TC:Bus Intercom Gateway

**Title: Doorman S3**

Rev: 1.6.1

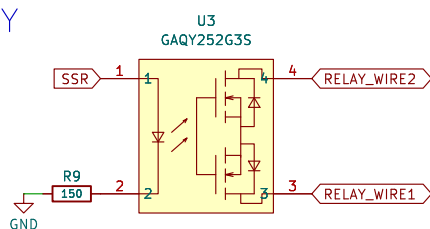
Fix Bus Wire polarity

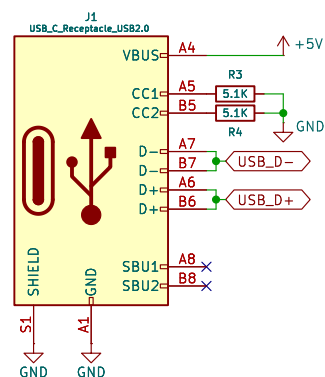
Capacitor needs to be directly connected to the bus. No Bridge rectifier inbetween!
